1st Further Information

**Proposed Temporary Place of Recreation, Sports or Culture (Hobby Farm) with Ancillary Eating Place and Associated Filling of Land for a Period of 5 Years in "Agriculture" ("AGR") Zone and Area shown as 'Road',
Various Lots in D.D. 17 and Adjoining Government Land, Ting Kok, Tai Po, New Territories**

(S.16 Planning Application No. A/NE-TK/843)

Response-to-Comment (RtC)

Private Car Swept Path Demonstration

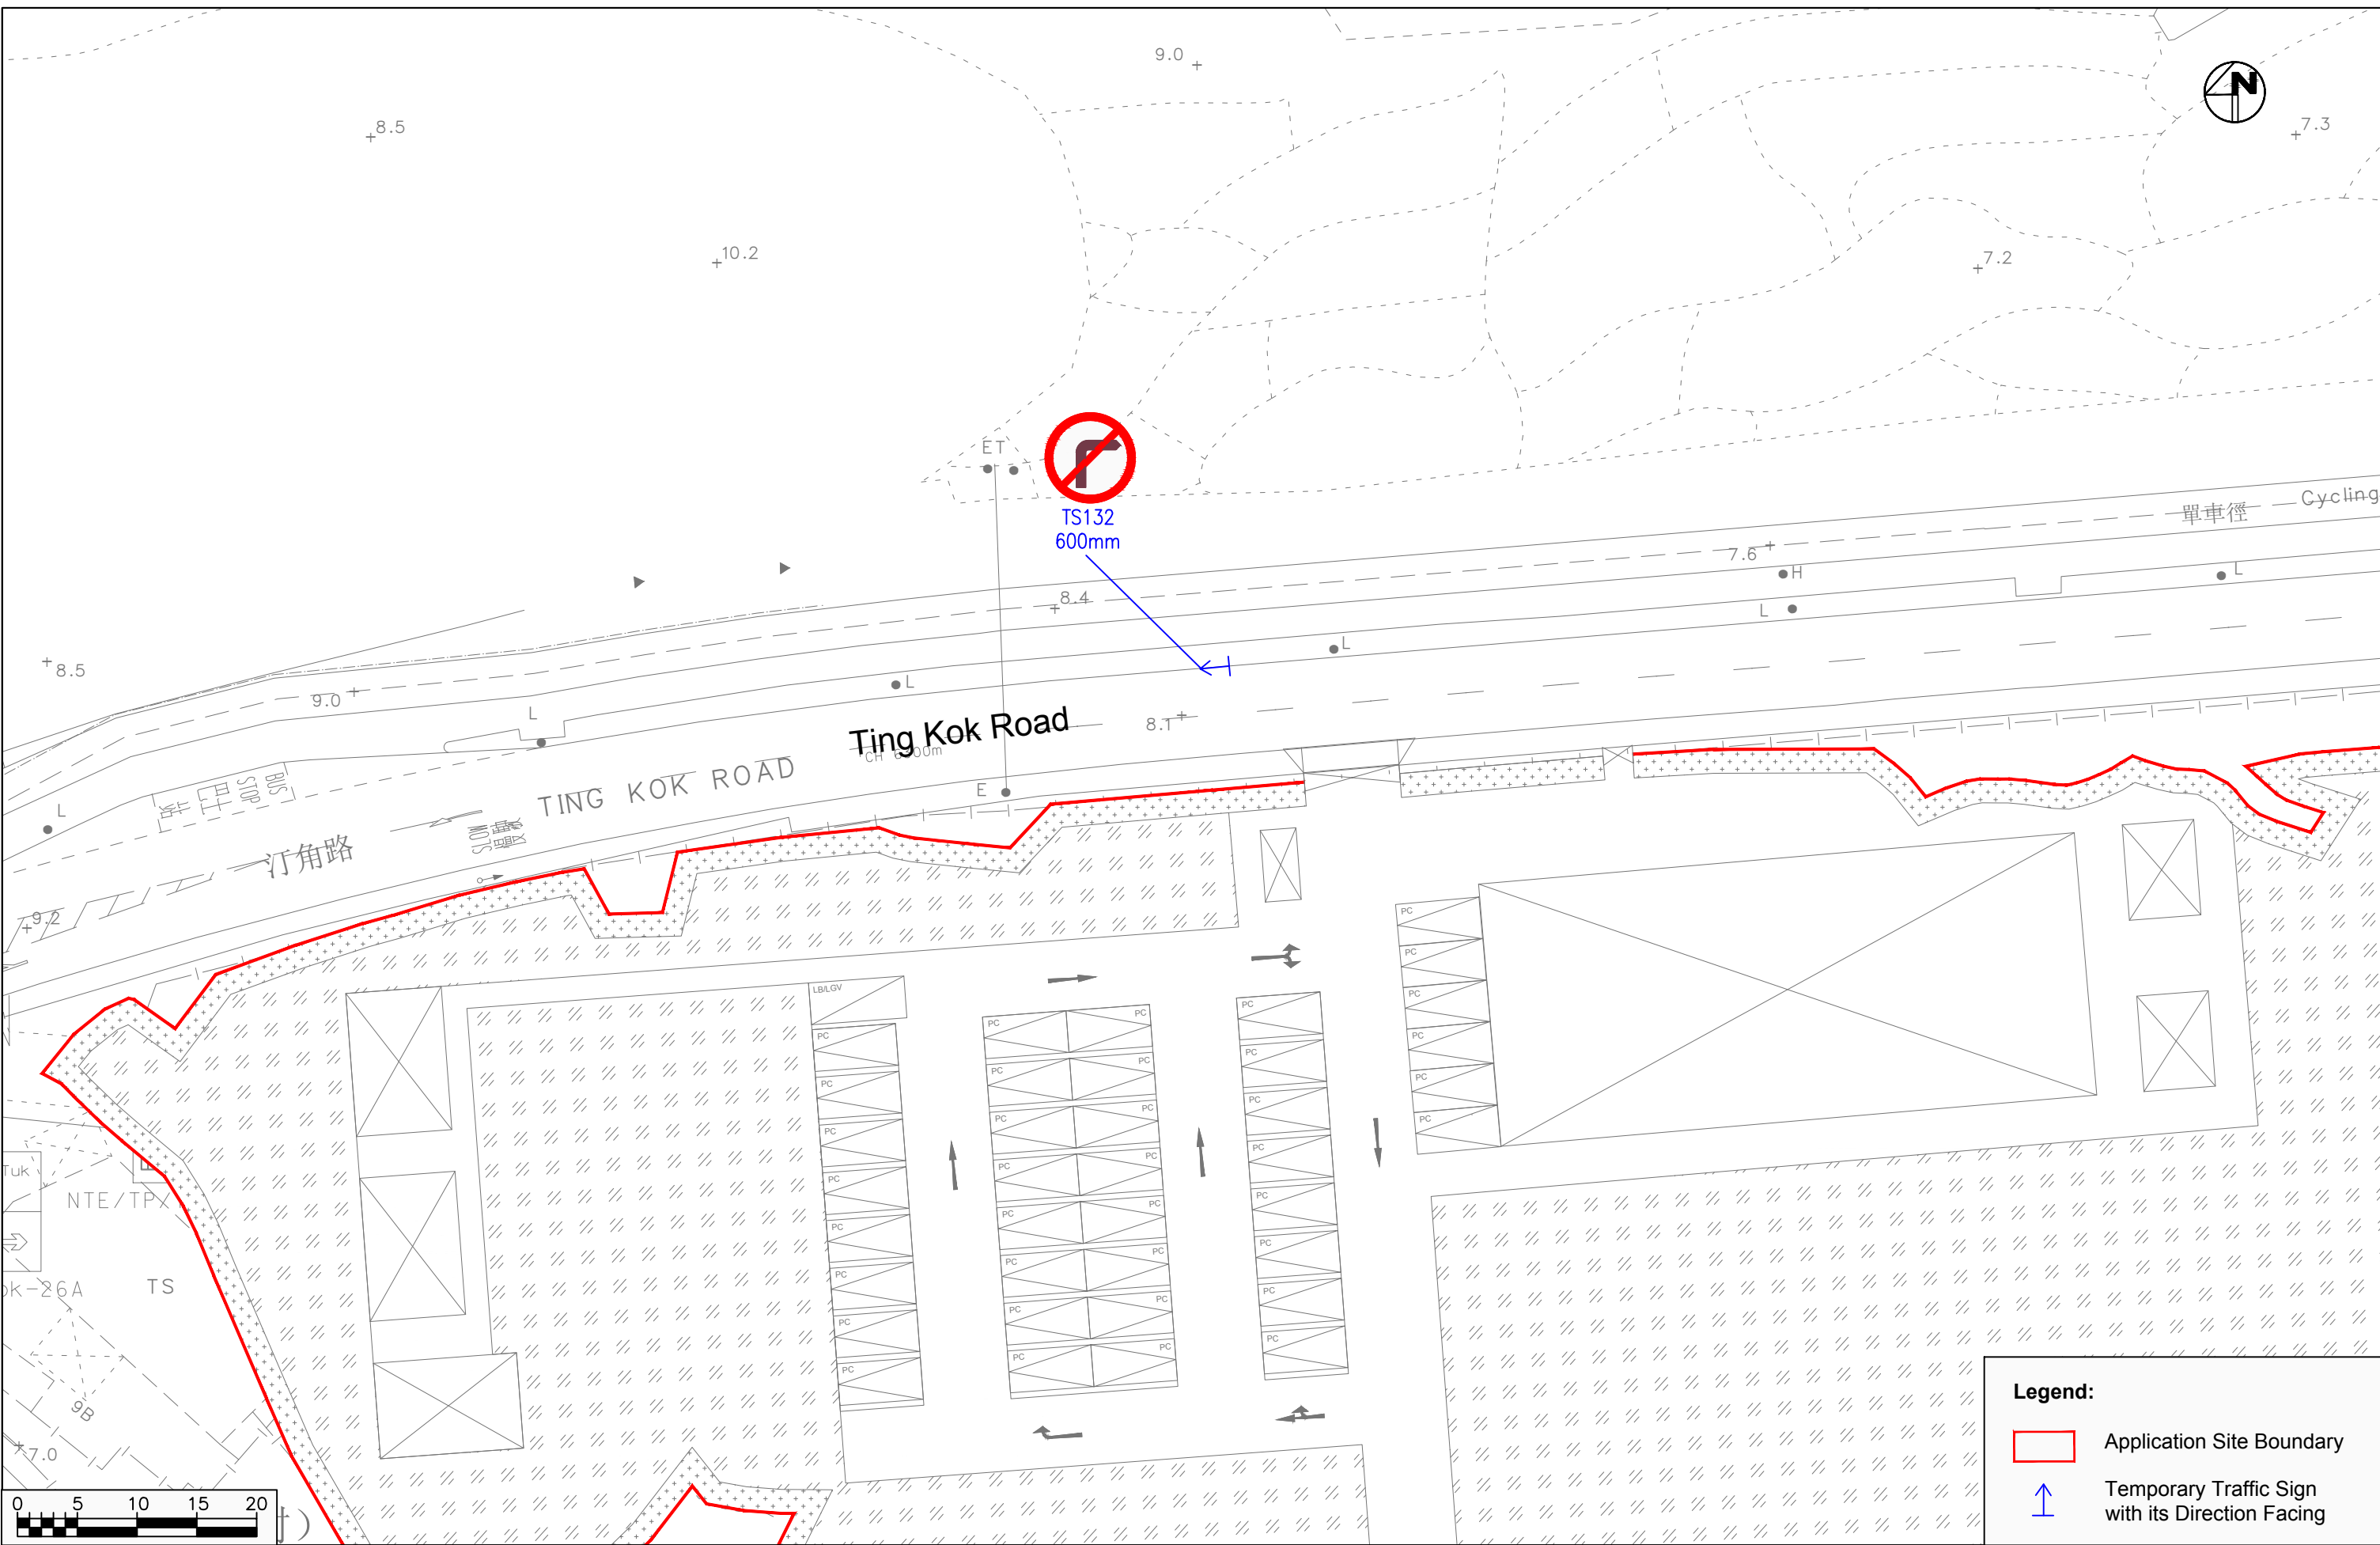
(e)	The applicant shall demonstrate the vehicles can be manoeuvred smoothly within the site without queuing on public road.	The swept path analyses are enclosed at Appendix A of Annex 3 . Sufficient space is provided for vehicles to manoeuvre smoothly within the Site to ensure that no vehicle will be allowed to queue back to or reverse onto/from the Site to public roads. Road markings are also proposed for clearer guidance within the Site.

Proposed Traffic Sign

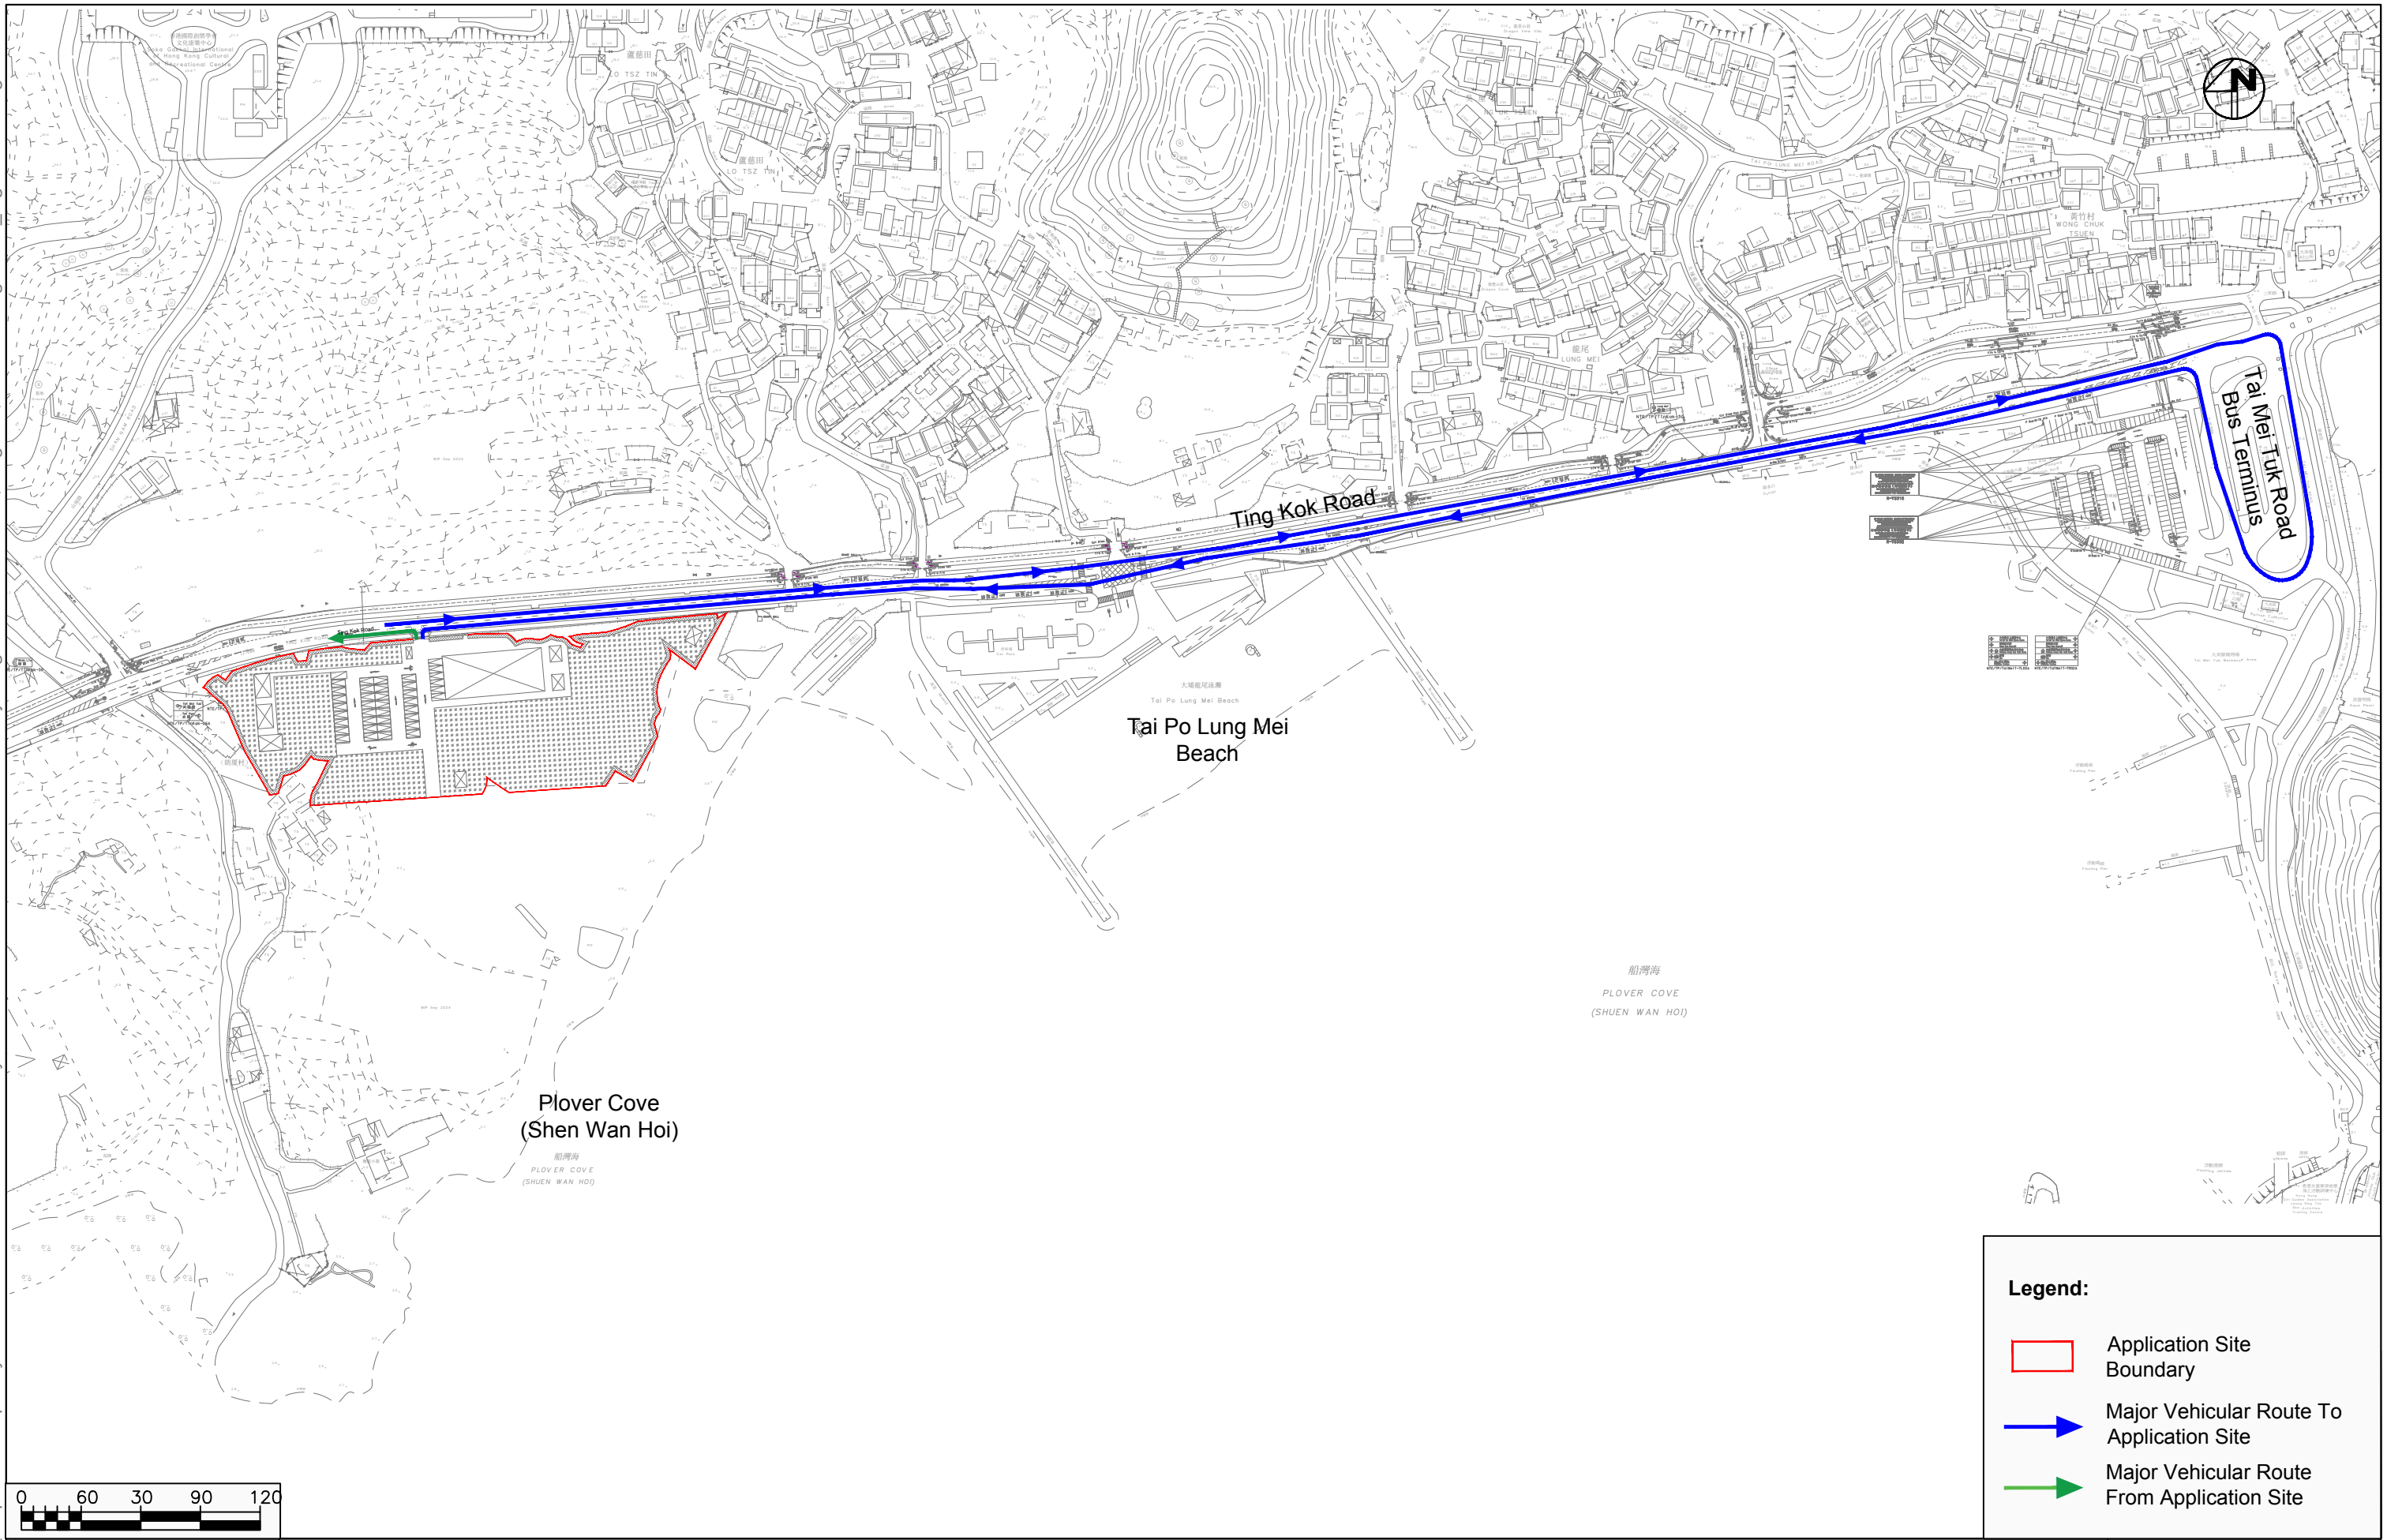
(f)	We received complaints regarding traffic congestion at Ting Kok Road eastbound due to vehicles waiting for right-turning to the access road connecting to the adjacent sites. The applicant shall provide a management plan to mitigate the potential queuing problem on the public road due to the proposed development accordingly.	Right-turning from Ting Kok Road eastbound will be prohibited, and traffic signs will be added accordingly. The proposed traffic signs and their locations are enclosed at Figures 1 and 2 of Annex 3 . Visitors will be informed that right-turning from Ting Kok Road eastbound will not be allowed upon reservation.

DWG. TITLE
 FSIs PROPOSAL (1/2)

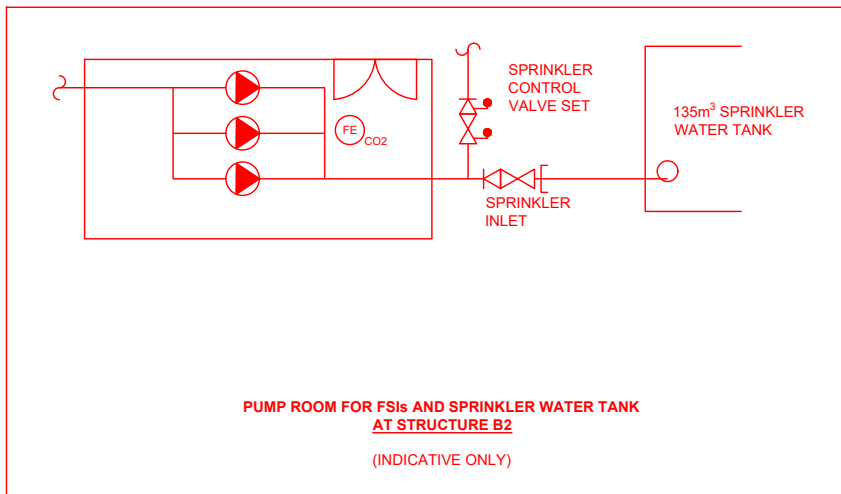
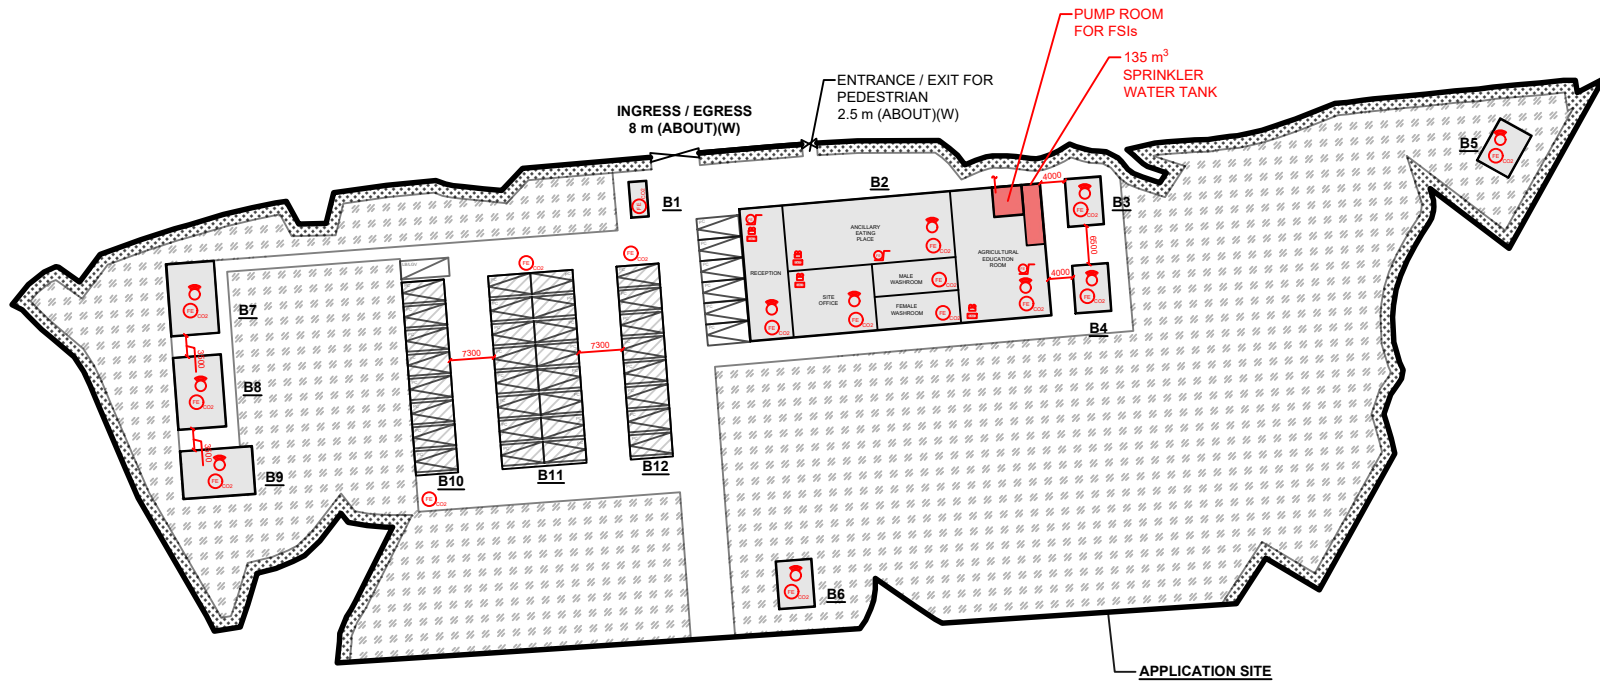
Departmental Comments		Applicant's Responses
11. Comments of the Director of Fire Services (D of FS)		
(a)	For any structures with total floor area exceeds 230 m ² , wheeled type dry chemical fire extinguisher, sprinkler system, emergency lighting, directional & exit signs and stand-alone fire detector shall be provided.	Noted. Please refer to the revised proposal at Annex 4.

(b)	Separation distance between each structure shall be clearly indicated on the plan.	
(c)	The automatic sprinkler system shall be provided in accordance with "BS EN 12845:2015 and the FSD Circular Letter No. 5/2020". The sprinkler tank, sprinkler pump room, sprinkler inlet and sprinkler control valve group shall be clearly marked on the plans.

(g)	For areas designated for storage purpose, the maximum storage area of a single block and the minimum clearance around each single storage block (i.e. 2.4 m) shall be specified in the FS Notes.	Noted. Please refer to the revised proposal at Annex 4.
